DHDC 22-7746-7747

CERTIFICATE OF APPROPRIATENESS

RE: Application Number 22-7746, 22-7747; 1127-1135 Vinewood St.; Hubbard Farms Historic District

1135 VINEYARD
DETROIT, MI

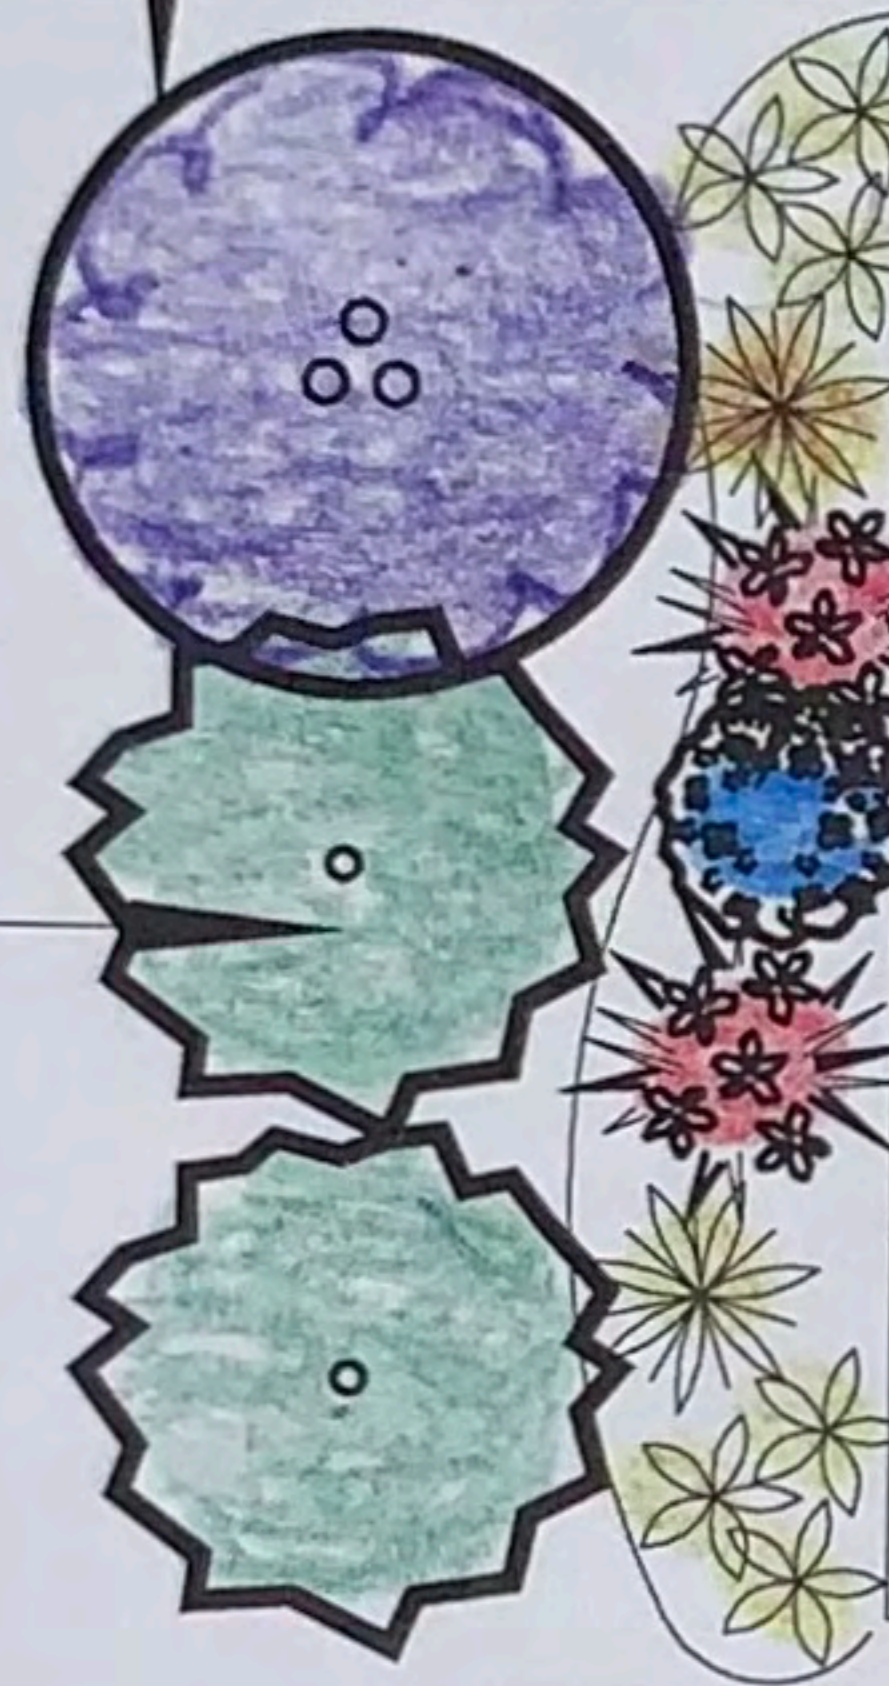
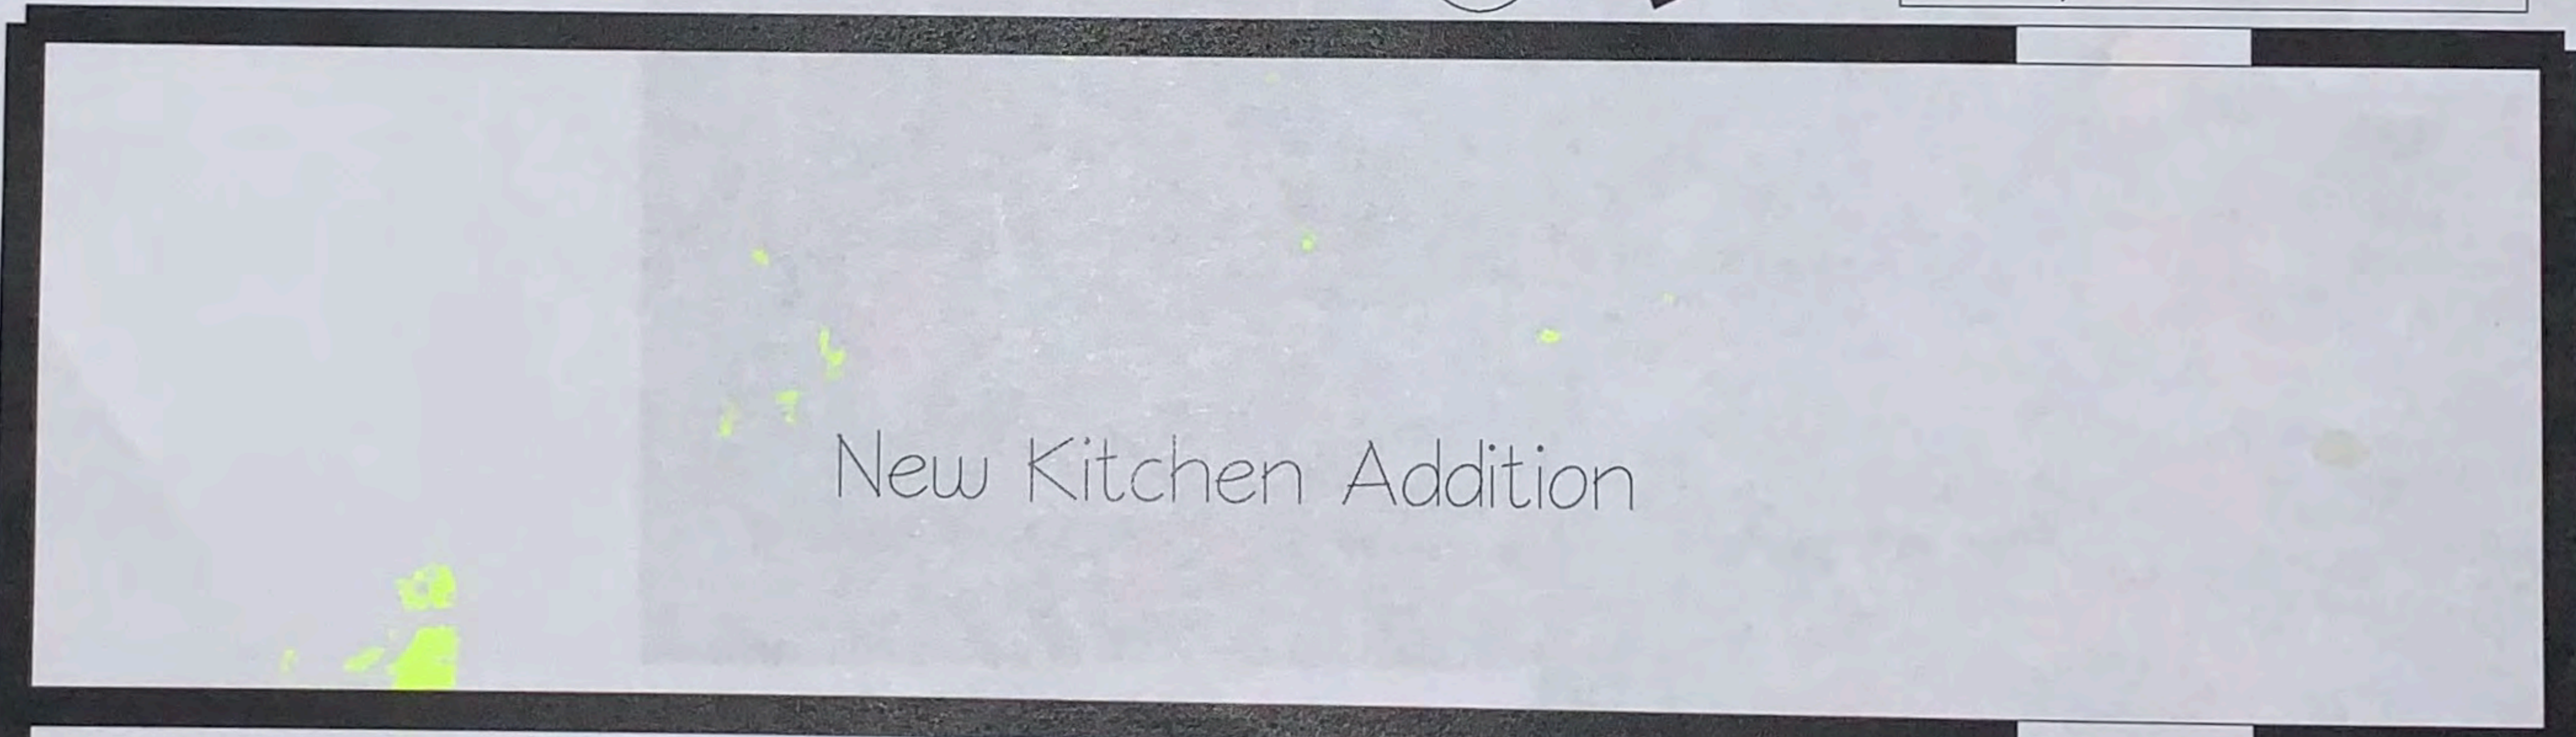
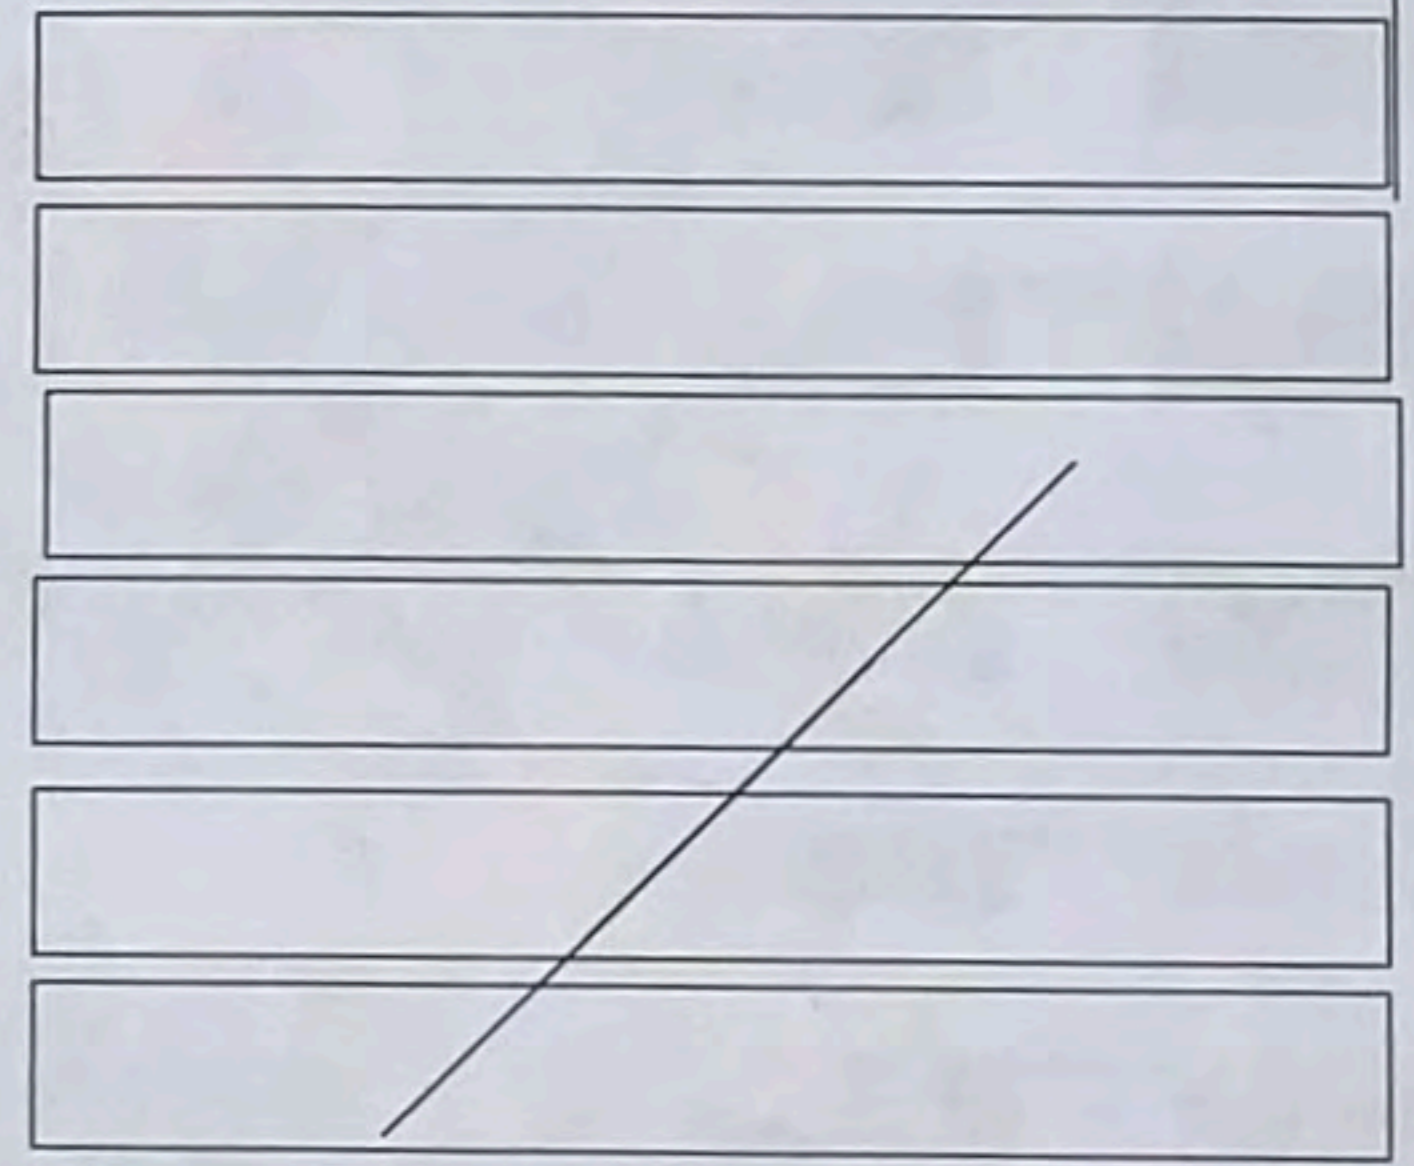
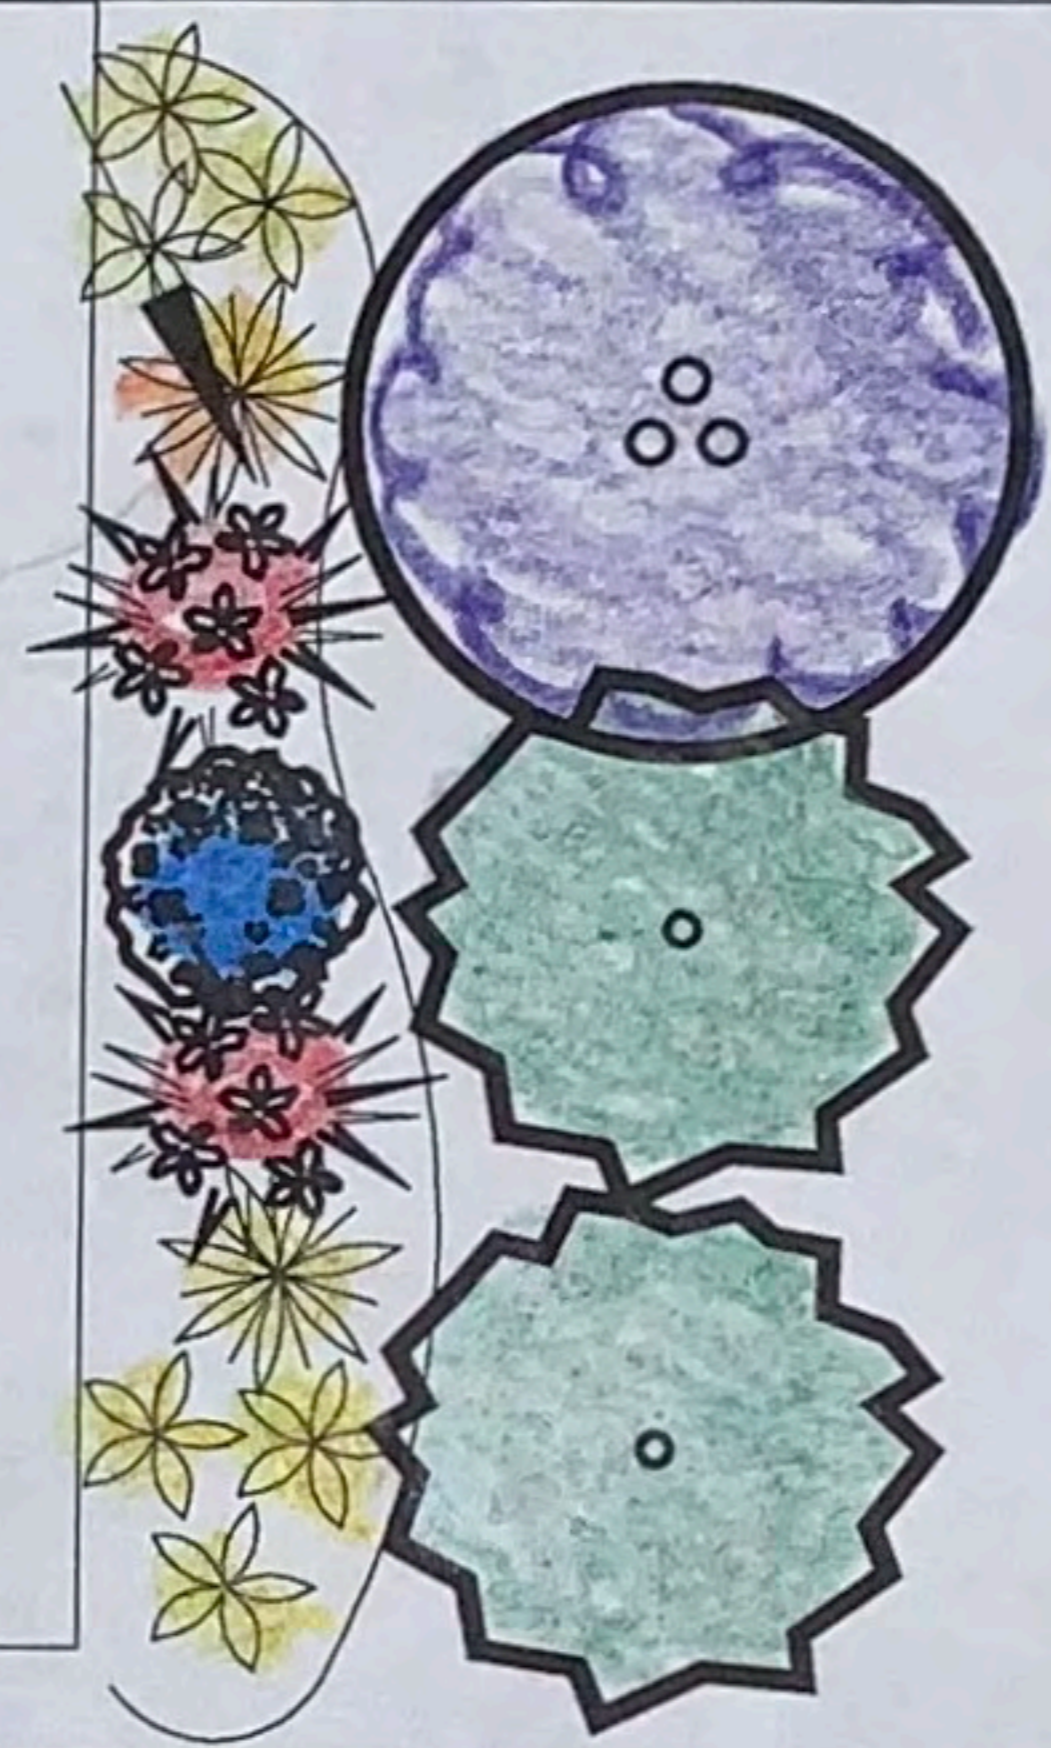
- *Staff be allowed to approve the final garage door design.*
- *The dog fence be made of a material that is not vinyl, preferably wood.*
- *The Hardie board siding be of a color that approximates the existing slate siding of the dormers.*
- *Staff receive a final landscape plan showing the location and species of proposed trees.*
- *The applicant provides HDC staff a review of the above items before installation.*

Thanks again for sorting through this with us. I've attached an updated plan with a few markups. The red line is a new fence between us and our neighbors to replace the existing chain link fence. See attached picture labeled South Fence for materiality - it will look like the 6' high portion, and then there will be a single scallop just to the back of our neighbor's house that will incorporate a gate so that we can see them to say hello.

The blue line shows the extent of the dog run fence from Louisa's previous email.

Per your suggestion, we will change the front path to the house from the sidewalk to be concrete. We would like the entire driveway to still be the "Pure" brick paver from Louisa's email. As you can see from the other pictures I've attached, the driveway is cracked all along it and very impractical because of how much narrower cars used to be. We run off the strips accidentally about 1 out of every 2 times we use the driveway. There is also precedent for pavers, since there are three sections of the driveway that have pavers filled in between the strips already.

Lastly, the rear patio is where the "Mista" paver would go.
